PP2015002, Little Bennett Regional Park Trail Connector: Preliminary Forest Conservation Plan and Preliminary/Final Water Quality Plan

- A. Little Bennett Regional Park Trail Connector:  
Preliminary Forest Conservation Plan No. PP2015002
- B. Little Bennett Regional Park Trail Connector:  
Preliminary/Final Water Quality Plan No. PP2015002

- **A. Staff Recommendation: Approval of Preliminary Forest Conservation Plan with conditions**
- **B. Staff Recommendation: Approval of Preliminary/Final Water Quality Plan with conditions**

Figure 3. Tree 30367 to be removed (Sheet 4 of FCP)

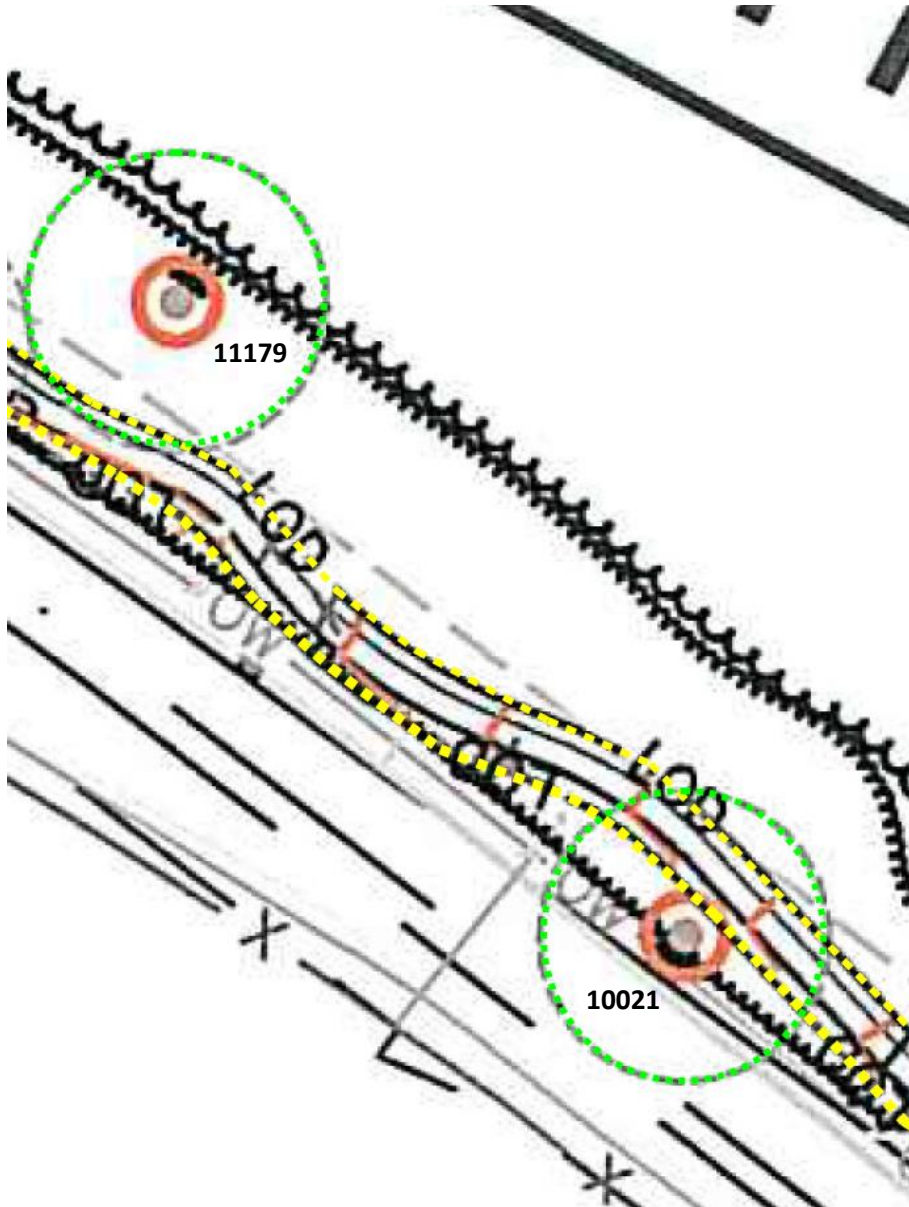
- 30367 – 34" DBH tulip tree, poor condition, undercut – stream restoration and grading along the right bank of Sopers Branch Tributary

Unwarranted Hardship Basis –Section 22A-21 states that a variance may only be considered if the Planning Board finds that leaving the Protected Trees in an undisturbed state would result in an unwarranted hardship, denying an applicant reasonable and significant use of a property. As outlined in the 2007 *Little Bennett Regional Park Master Plan* and per the 2011 *Little Bennett Regional Park Day Use Area Facility Plan*, the Applicant proposes to construct a trail connection to provide pedestrian access from the existing asphalt trail from Snowden Farm Parkway near Little Bennett Regional Park Maintenance Yard to the southern entrance of the future Day Use Area of Little Bennett Regional Park. Additionally, the Applicant proposes to stabilize and restore a stream channel in the vicinity. The Application notes that an unwarranted hardship would be created due to the specific location and requirements of the trail connection to connect the existing trail to the recreation area, existing conditions on and adjacent to the Property including the existing MD 355 and the number and location of Protected Trees on the site, and maintaining the accepted design standards for constructing the trail connection. There are Protected Trees located throughout the Property. The one tree proposed for removal is in poor condition, and undercut by the eroding stream bank. It will not be possible to restore and stabilize the stream bank without removing this tree.

Mitigation for Protected Trees Subject to the Variance Provision – The one Protected Tree proposed to be removed is located outside of existing forest and Staff recommends mitigation for the loss of this tree. Staff recommends the Applicants plant three (3) three-inch caliper native canopy trees as mitigation for the loss of the one Protected Tree.

3. The Applicant must provide mitigation for the loss of trees requiring a variance in the form of three (3) native canopy trees with a minimum size of three (3) caliper inches. The trees must be planted on the Subject Property outside of any right-of-way, or utility easements, including stormwater management easements within one year of construction completion.

Variance Recommendation – Staff recommends that the variance be granted to permit the removal of one Protected Tree, and impacts to four Protected Trees, with mitigation provided in the form of planting three, 3-inch caliper native canopy trees on the Property.

Figure 4. Trees 10121 and 11179 Impacts (Sheet 2 of FCP)

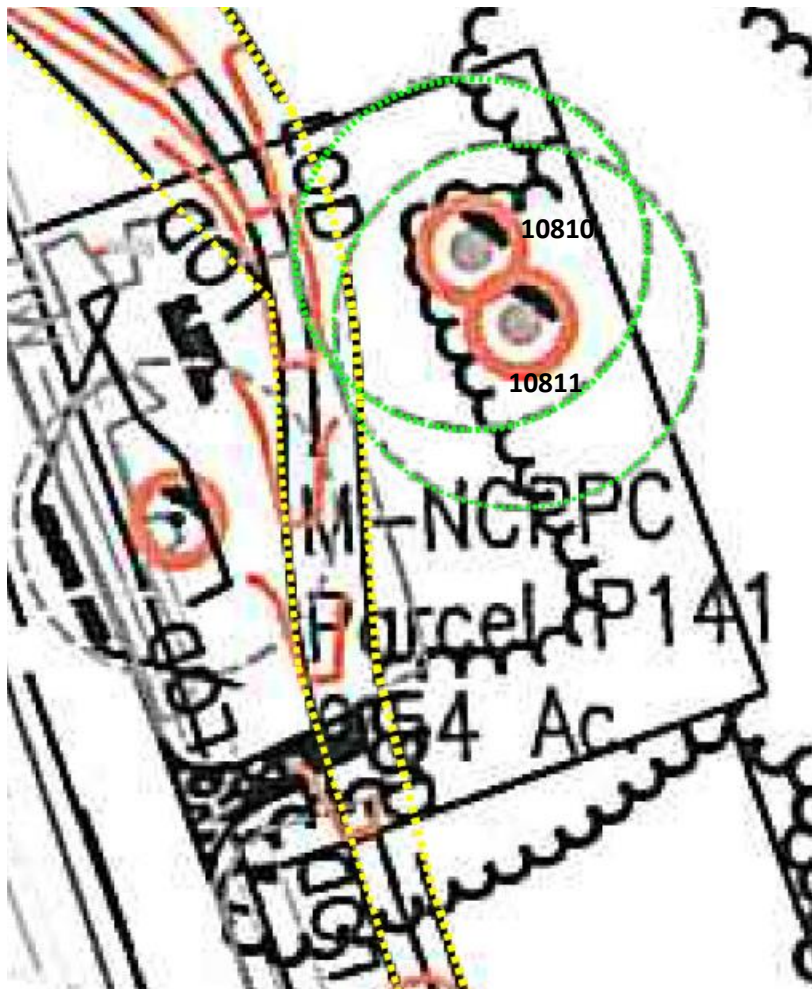
- 10021 – 30" DBH red oak, fair condition – grading, trail; 32% critical root zone (CRZ) impact
- 10810 – 30" DBH silver maple, good condition – grading, trail; 4% CRZ impact
- 10811 – 31" DBH silver maple, good condition – grading, trail; 1% CRZ impact
- 11179 – 31" DBH white oak, good condition - trail; 1.3% CRZ impact

The four Protected Trees proposed to be affected but retained, will be minimally impacted due to grading and trail construction. Measures taken to minimize impacts to the trees include constructing the trails on grade or elevated on piers, where feasible. Where the trail traverses the forest and wetlands near the stream, over 900 feet of trail will be elevated on piers. All of the affected trees will receive tree protection measures during construction. Staff finds that an unwarranted hardship would be created if a variance were not considered.
